PRODUCT/PROCESS CHANGE NOTICE (PCN)

PCN #: TB-0609-03 DATE: 06-Oct-2006 Product Affected: All square PQFP and TQFP, MLP Dual, QFP-N, VFQFP-N packages shipped in Tape and Reel Date Effective: 06-Nov-2006	MEANS OF DISTINGUISHING CHANGED DEVICES: <input type="checkbox"/> Product Mark <input type="checkbox"/> Back Mark <input type="checkbox"/> Date Code <input checked="" type="checkbox"/> Other Starting 06-Nov-2006
---	---

ATTACHMENT I - PCN #: TB-0609-03

FROM:

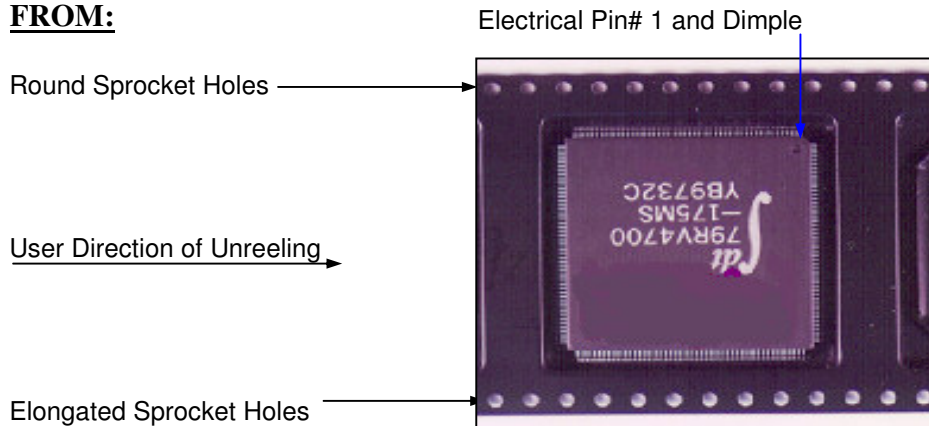
PCN Type: To comply to current EIA Standard (EIA-481-C) requirement.

Detail of Change: This change will be implemented on all square PQFP and TQFP, MLP Dual, QFP-N, VFQFP-N packages.

Conversion Schedule:

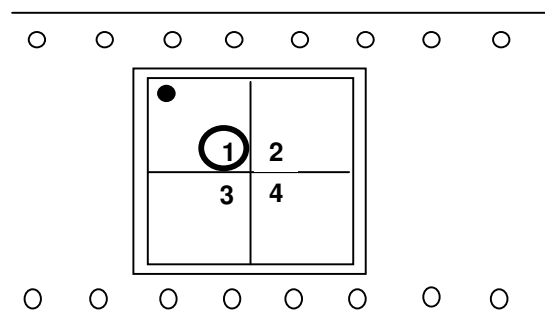
Additional label as shown below will be placed on the intermediate box (pizza box) to alert customer of this change. Label will be placed starting 06-Nov-2006 until 06-Nov-2007. However, please take note that IDT will continue to ship products in existing loading orientation until the inventory has been depleted. Customer may receive shipments in existing or new loading orientation.
